HISTORIC LANDMARK COMMISSION

APPLICATION FOR A CERTIFICATE OF APPROPRIATENESS MARCH 22, 2021 C14H-2009-0065

Judge David J. and Birdie Pickle House 1515 MURRAY LANE

Source: Google Street View, February 2019. The proposed fence will be located at the front right corner of the building.

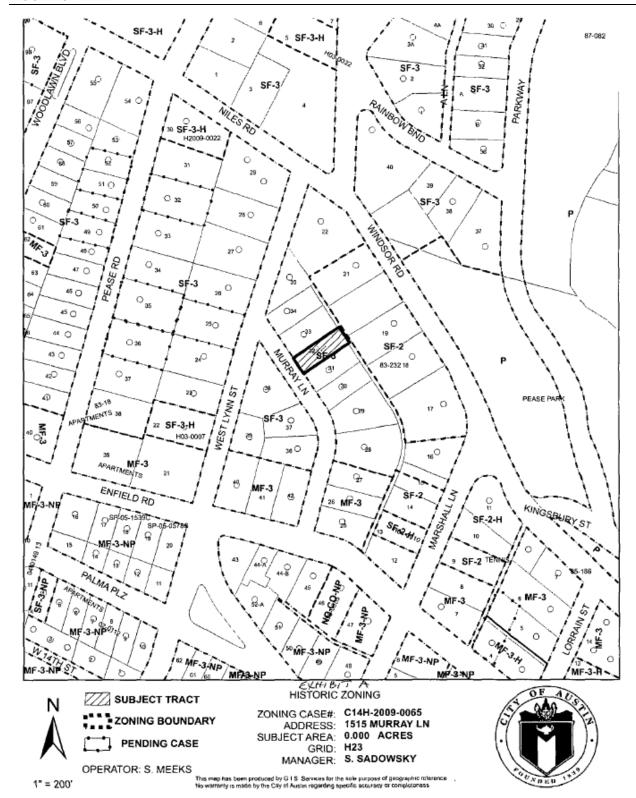
Consider materials other than masonry for the wall; consider a location set back from the front façade of the house. The applicant responded to both comments by changing the materials and location for the proposed fence.

Approve the application.
